References: (a) Construction Permit CPPR-135 and CPPR-136,
Docket Numbers 50-443 and 50-444
(b) USNRC Letter, dated October 1, 1982, "Request for
Additional Information (PSB and EQB)", Janis Kerrigan to
W. C. Tallman

Subject: Analysis on Associated Circuits

PUBLIC SERVICE COMPANY OF NEW HAMPSHIRE
SEABROOK STATION - UNITS 1 & 2

FIGURE 1

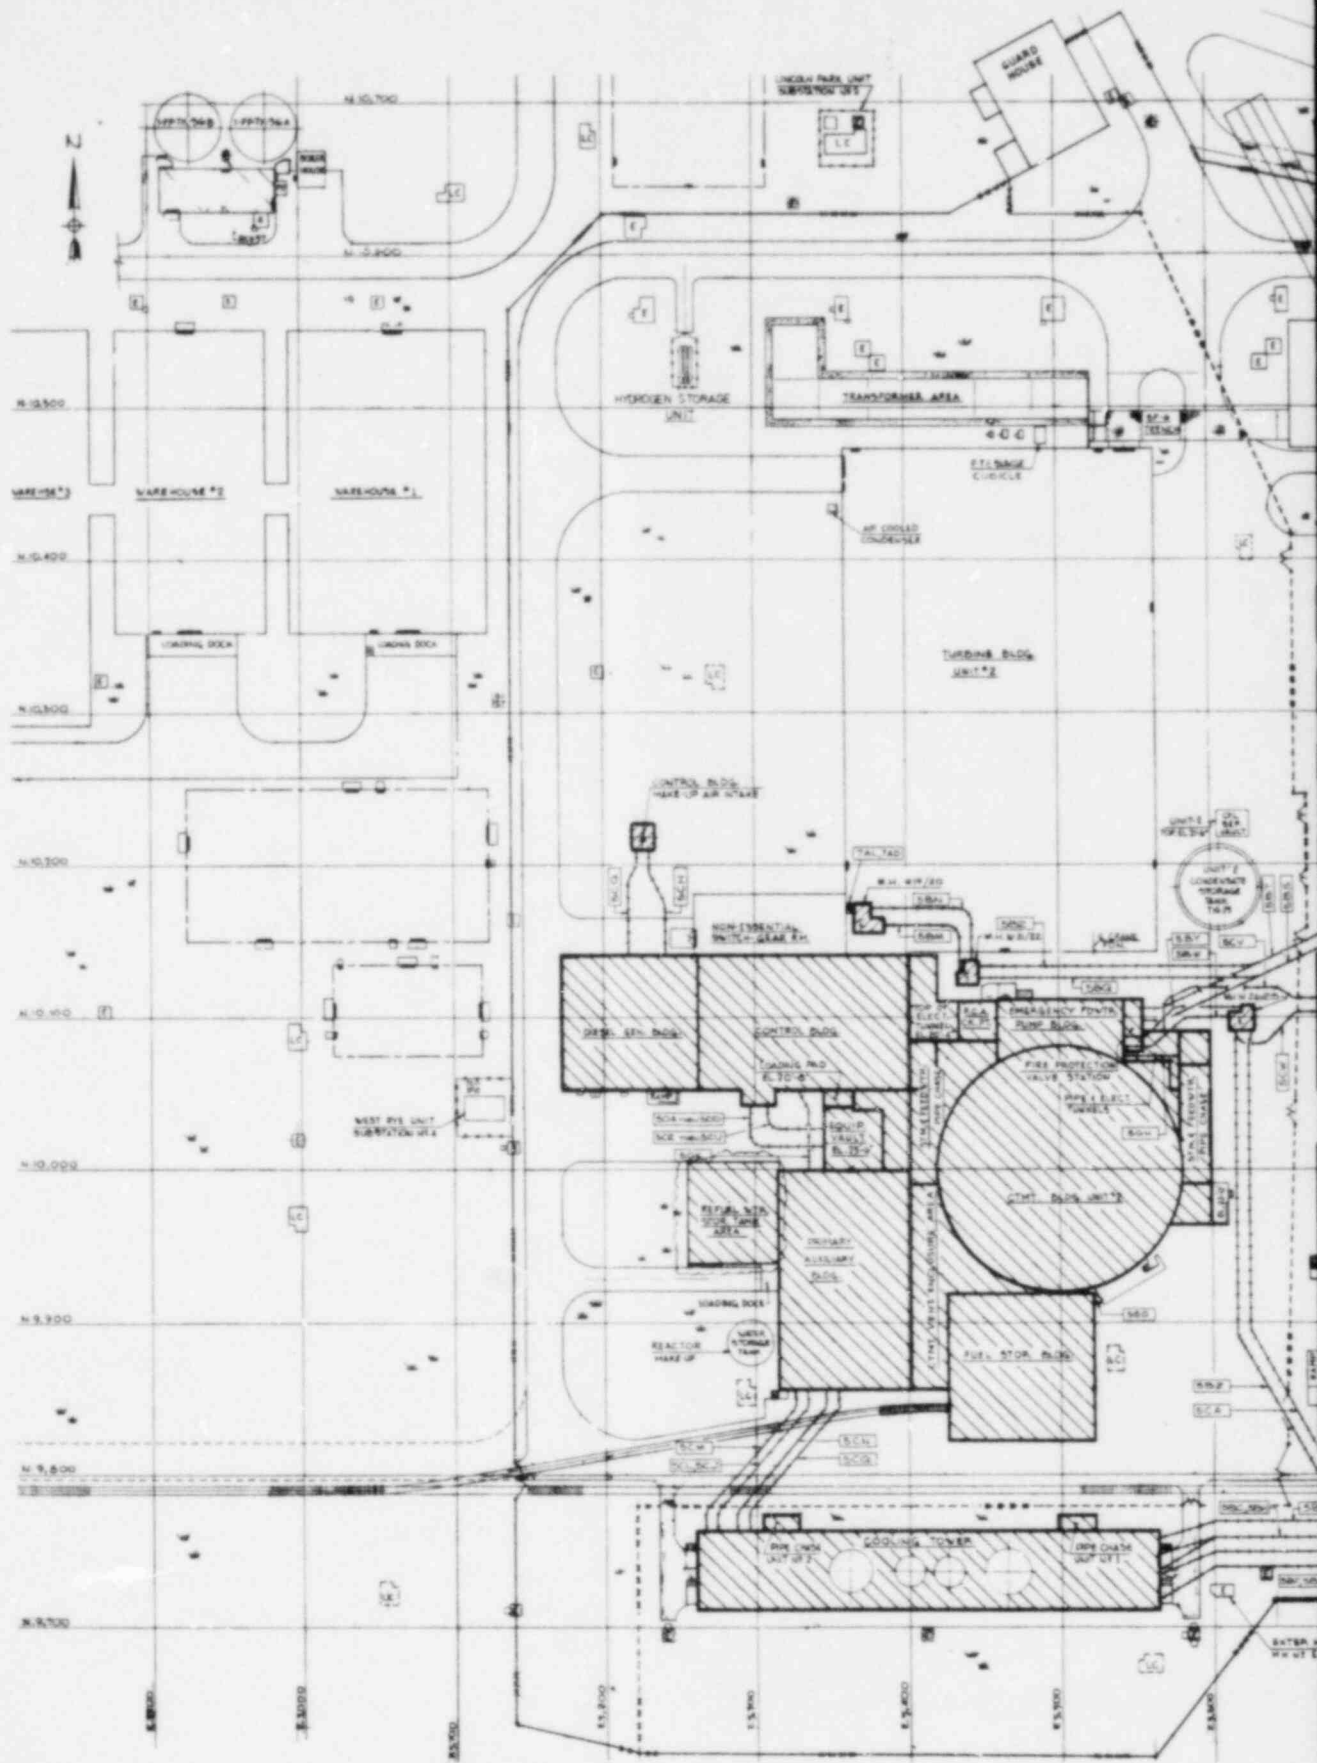
Provide the results of an analysis to prove that any challenges to Class 1E Circuits from associated circuits do not prevent the safe shutdown of the plant.

As a result of this design, all plant circuits are specifically assigned to one of the following four separation groups as noted in Figure 1.

- Group A - Train A, Channel I and Train A Associated Circuits
- Group B - Train B, Channel II and Train B Associated Circuits
- Group C - Channel III
- Group D - Channel IV

The great majority of associated circuits are with Group A, a very limited number are with Group B, and none are with Groups C and D.
